Subject: Westinghouse Hematite Decommissioning Project: Response to NRC Request for Additional Information dated July 10, 2013, on the May 28, 2013, HDP 20.2002 Alternate Disposal Request (License No. SNM-00033, Docket No. 070-00036)

**Response to NRC Requests for Additional Information on the
20.2002 Request Dated May 28, 2013**

TITLE: Safety Assessment for Third Alternative Disposal
Request for Transfer of Hematite Project Waste to
USEI

Figure 1. Sludge Sample Locations in the Sanitary Wastewater Treatment Plant

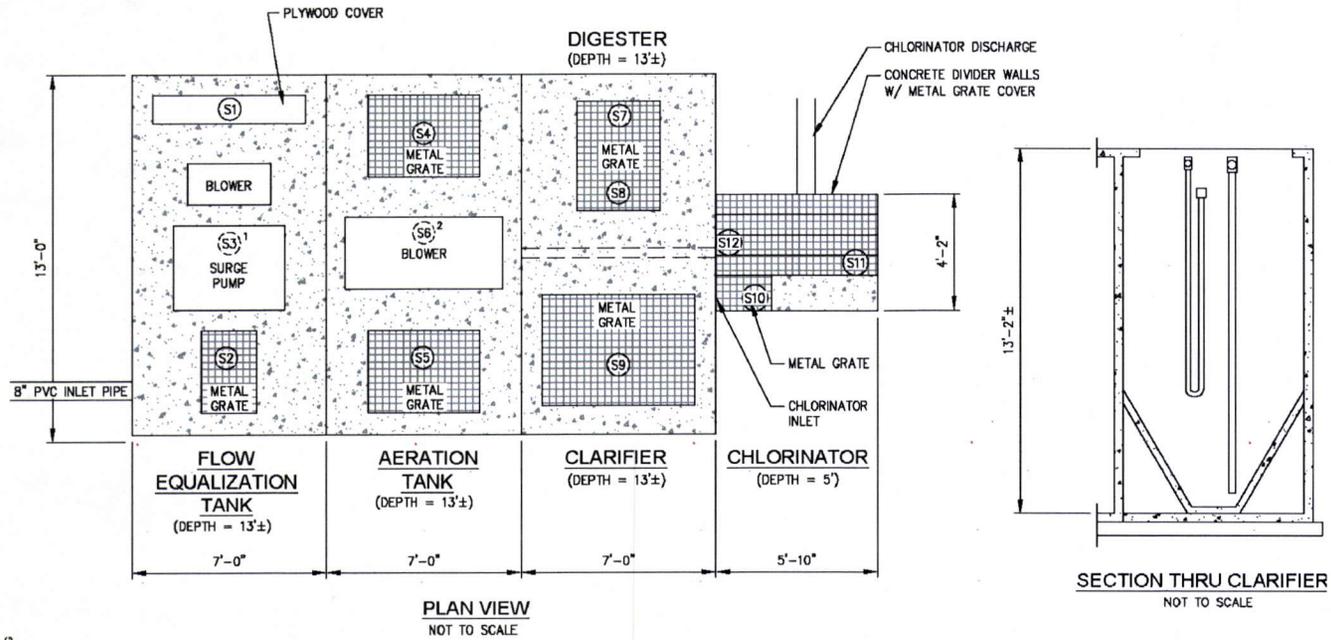
6	Waste Characterization Plan (5.2)	Sampling of soil and soil-like materials	10CFR20.2002(d)	In Section 5.2 it was noted that the same approach would be used to sample both soil and soil-like materials, but it was not clear whether or not populations of soil would be sampled separately from soil-like materials (or if Westinghouse intends to mix soil-like materials into soil prior to sampling). Currently, the NRC staff does not have sufficient characterization information to fully assess the similarity of soil and soil-like materials. As such, it would be prudent to sample soil and soil like materials separately (i.e., prior to any mixing.)	Please provide clarification that soil and soil-like materials will be sampled separately or provide justification for mixing the populations.	The third paragraph of Section 5.2 has been revised to identify that dewatered sanitary sludge will be sampled prior to commingling with soil or other waste. After the characterization results of dewatered sanitary sludge are obtained and evaluated to meet the Table 2 criteria, then it can be commingled with soil.

The characterization of dewatered sanitary system sludge, being readied for shipment will consist of 12 samples taken following dewatering. The 12 samples will be taken from random locations within the dewatering containers. Software will be used to randomly select each of the three coordinates that comprise the sampling location within the dewatering container. This characterization of dewatered sanitary sludge will occur prior to commingling with soil or other waste. After the characterization results of dewatered sanitary sludge are obtained and evaluated to meet the 20.2002 criteria, then it can be commingled with soil or other waste. The number of samples based on attaining a confidence interval of 35 pCi/g, based on analysis of the July 2013 characterization data using Visual Sample Plan[©], as reported in Appendix D. The randomness of sample locations is also based on Appendix D. The sample results will be compared to the combined contingency plan limits in Table 2.

Available characterization data of sanitary system sludge is provided in Table 3. The upper half of the table is older data and the lower half of the table is July 2013 data. Figure 1 shows the locations within the Sanitary Wastewater Treatment Plant where the July 2013 sludge samples were taken. For each of the nine density measurements, dewatering was simulated by the passing a portion of the sample through a paint filter and taking the measurement on what remained of that sample on the filter. The July 2013 sludge samples
